RE: Sunfish Lake – Planning Update for August City Council Meeting

PLANNING REPORT - Major Site and Building Plan Review & CUP

RE: Sunfish Lake – 8 Roanoke Road – Site and Building Plan Review & CUP

PLANNING REPORT – Site and Building Plan Review & CUP Addendum

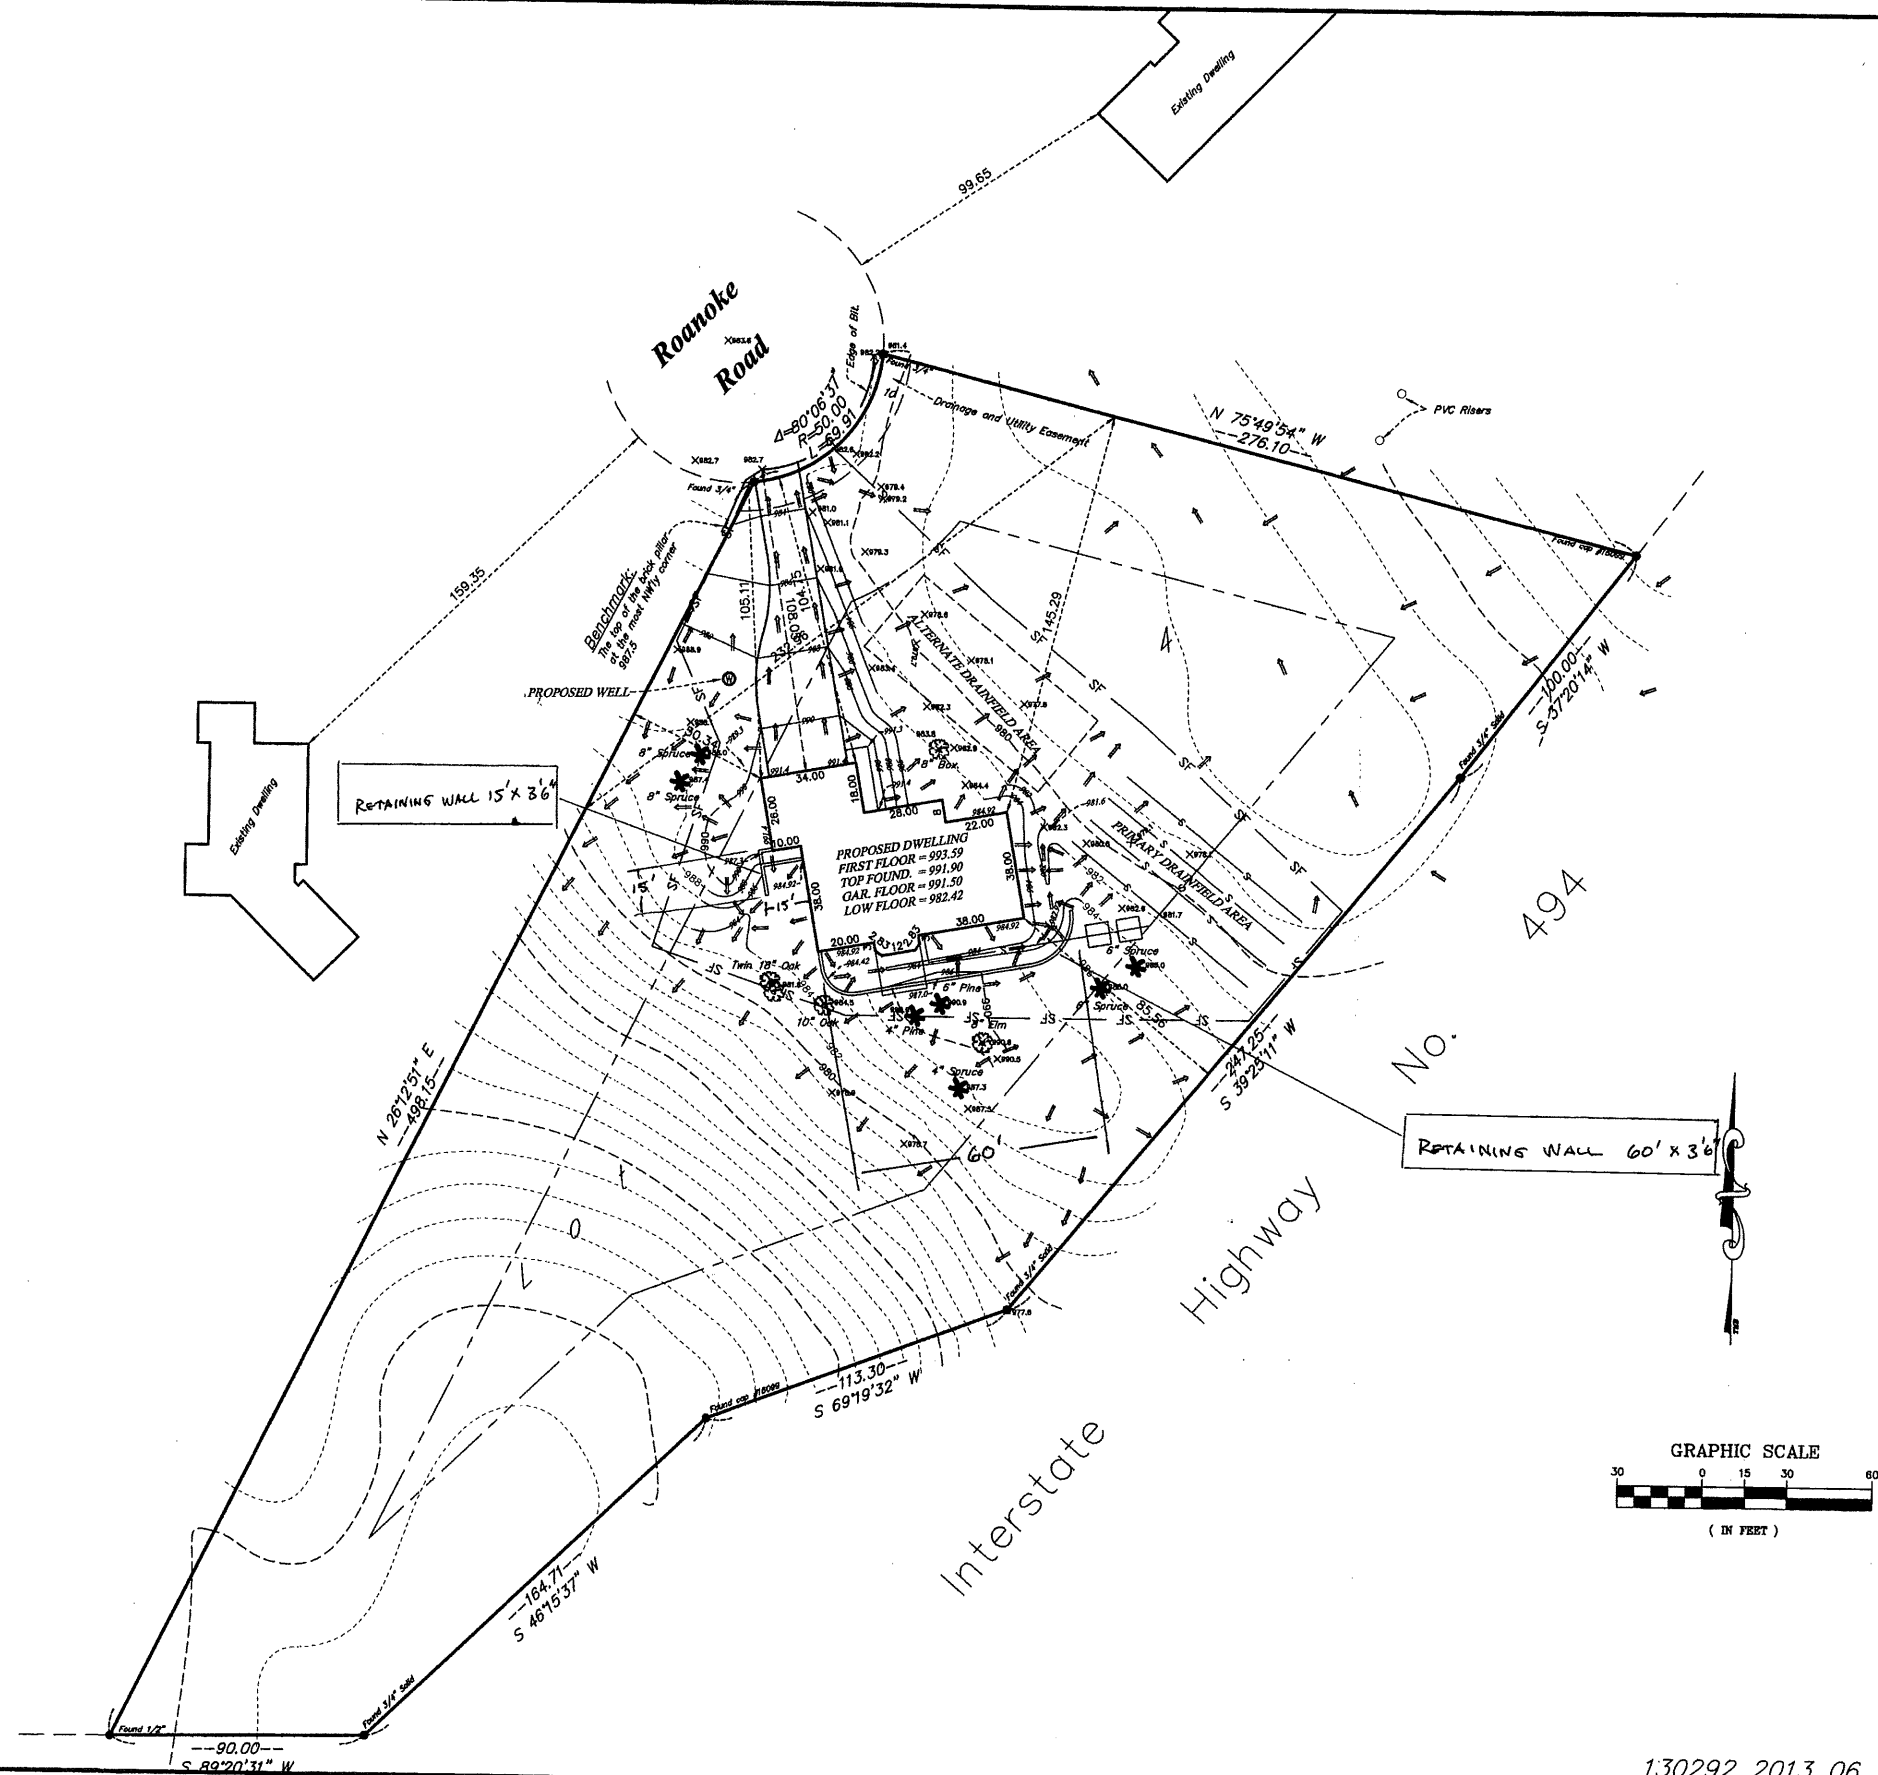
- Setback lines appear to have been shown on the plans, but please label these.
- Please fix the line in legend for Silt Fence. This is incorrect.
- In lieu of silt fence, the applicant may want to consider a straw bio-roll (staked) to minimize the land disturbance caused by installing and removing silt fences.
- Please show the type of driveway material, bituminous, concrete, etc.

The applicant's proposed site grading shows a positive slope away from the house foundation, therefore, should require no modifications to the proposed grading plan around the house. However careful attention to the grading must be maintain along the west property line so drainage is directed south and not west onto the adjacent property. Sufficient grades to the east and west of the driveway are not shown to determine if a driveway culvert is necessary. Please provide this information and if a culvert is necessary specify the size, invert elevation and type of material.

The proposed, temporary stockpile location(s) need to be at locations that are within 50 feet of a driving surface for the Sunfish Lake building ordinances. Please revise these locations. The applicant will need to construct and maintain a rock construction entrance of approximately 50 feet in length and 20-feet wide at a point where the contractor is entering the paved surface and leaving an exposed dirt area to minimize tracking of material off the project site. This must be shown on the plans.

Please provide the area of land to be disturbed. A National Pollutant Discharge Elimination System NPDES Construction permit will be required if over an acre of land it to be disturbed.
